ASUS FX506H GN20-P0/P1 N18P-G61-A Block Diagram

Model
FX506HE
FX506HHR

CHANGE LIST

ROM Side

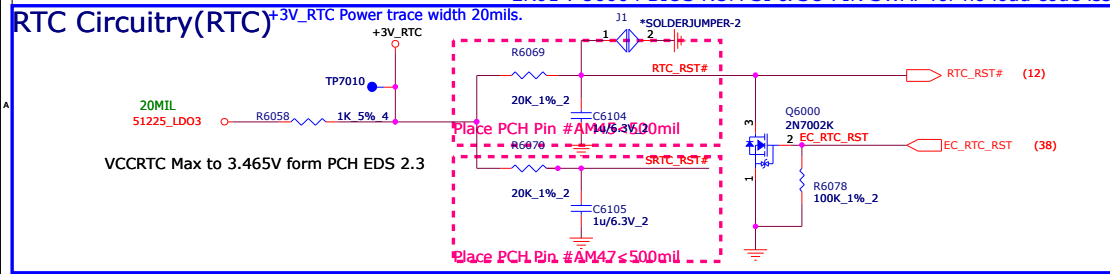
ER01 : U6004 BIOS ROM SI & SO PIN SWAP for no load code issue.

RTC Circuitry(RTC)

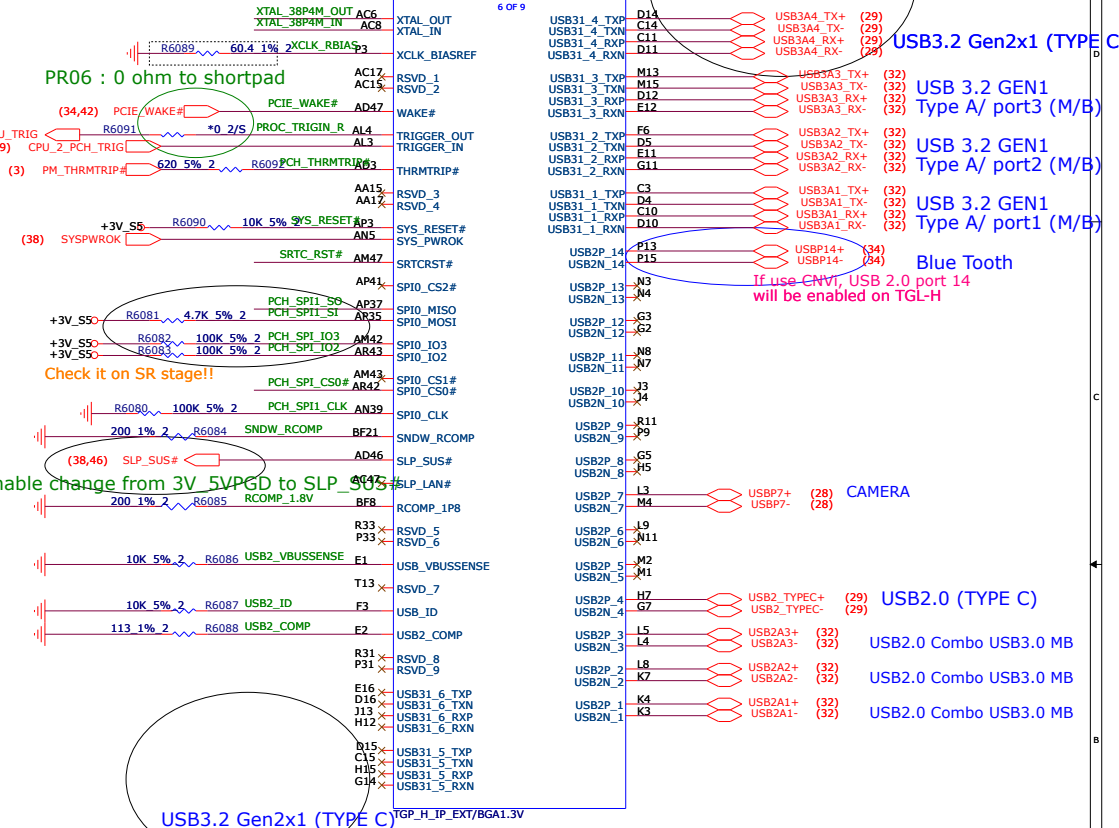
ER06 : C6107 & C6108 chnage from 15P to 12P for X'tal Accuracy.

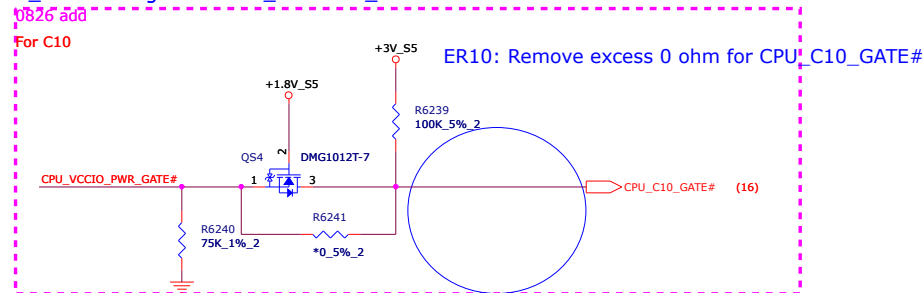
ER13 : DGPU_PWR_EN change GPIO from GPP_I10 to GPP_G3;
DGPU_HOLD_RST# change from GPP_I9 to GPP_G4

ER10: Remove excess 0 ohm for CPU_C10_GATE#

USB 2.0 PORT1

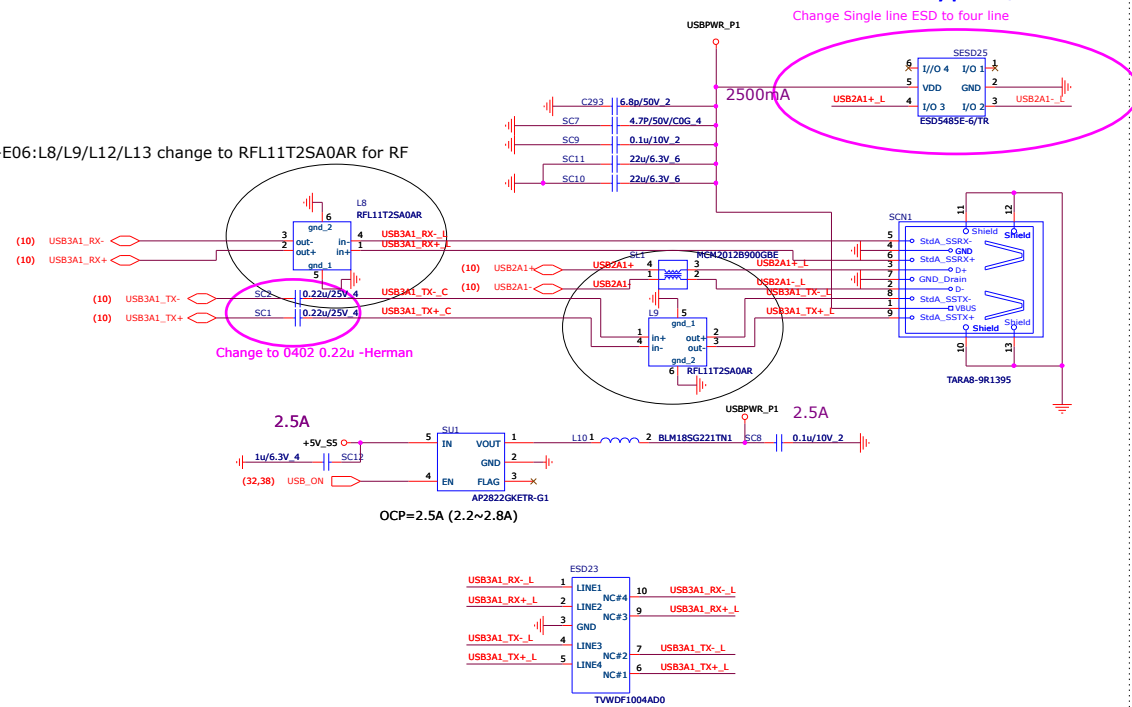
PR-E06:L8/L9/L12/L13 change to RFL11T2SA0AR for RF

NGFF Wifi/BT (Hybrid Type E)

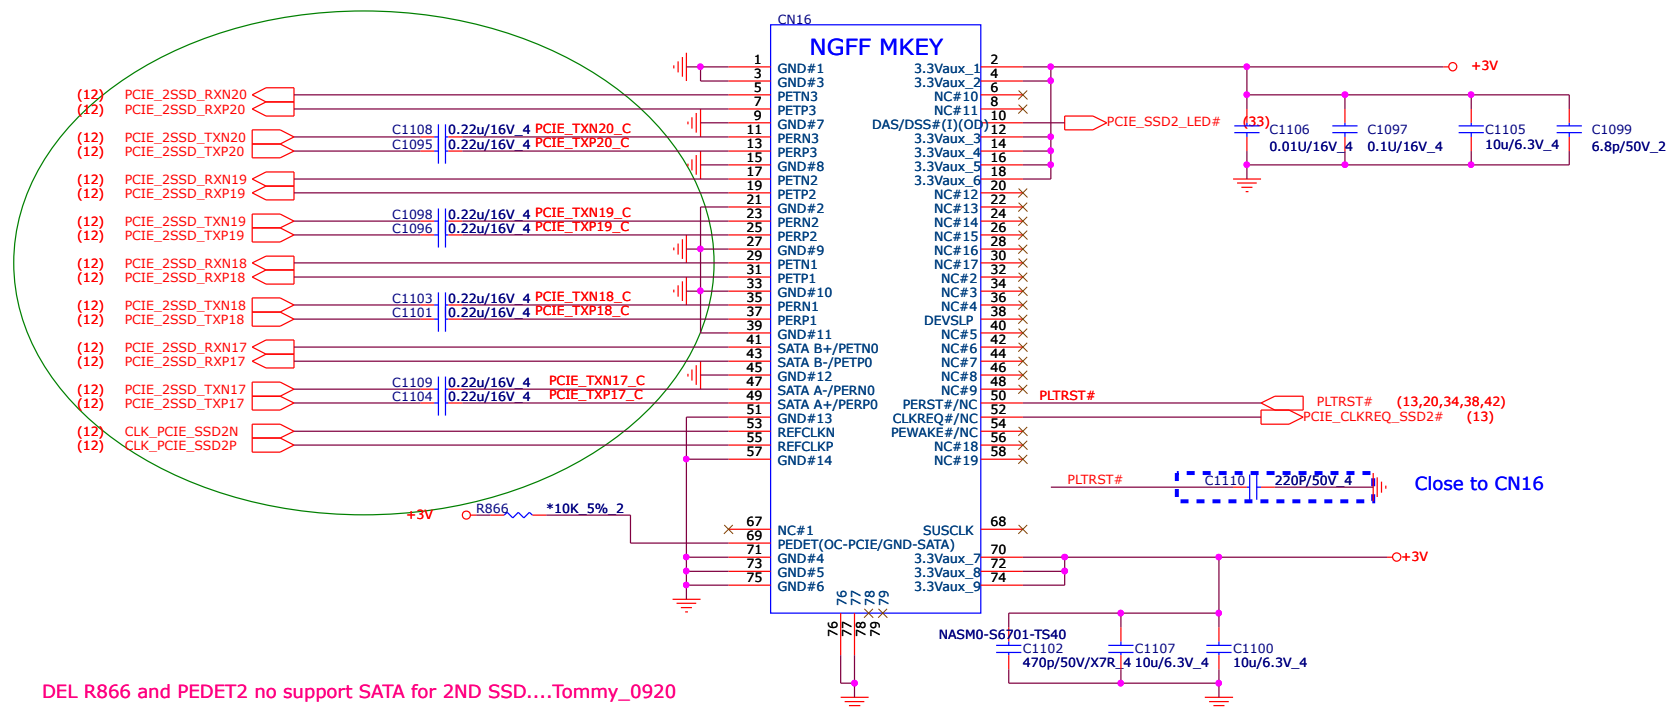
PR17 : 2nd SSD change from PCIE21~24 to PCIE17~20

Touch Pad Connector AA type

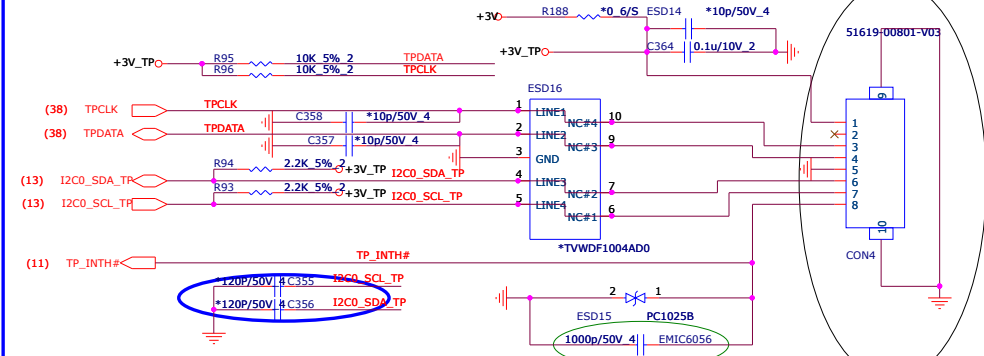
PR13 : TP_INT# add 1000p for EMI

KEYBOARD Con.

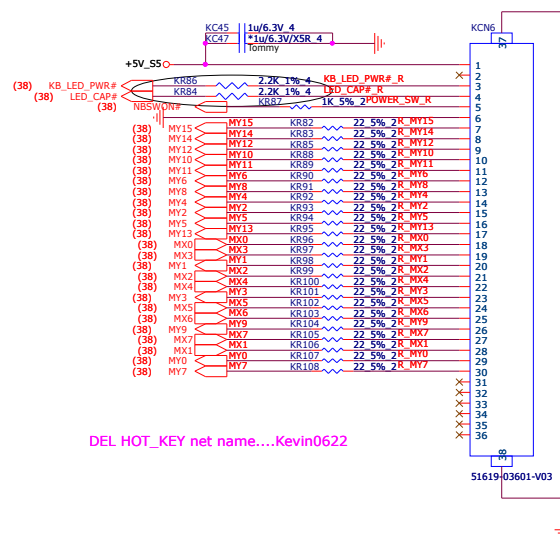
PR-E10:KR84, KR86 change from 220 ohm to 2.2K ohm for ID KB LED brightness request.

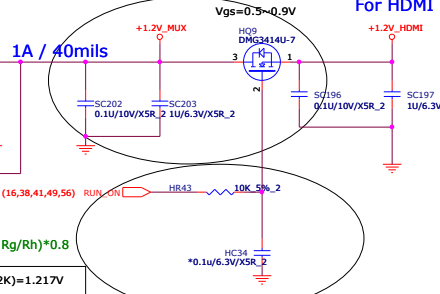
²PR07 : HDMI re-driver PS8209 change to PS8409 for Jitter issue

ER-026: Change 2.1ohm to 5.1ohm for fix TDR issue....112

ER11: HDMI TMDS Resistor change from 5.1R to 0R, and HL1 change to HCM2012GD500AE base on EA report.

PR-E08:HDMI DDC pull-up resistor change from 2.2K to 3K for HDMI protocol issue
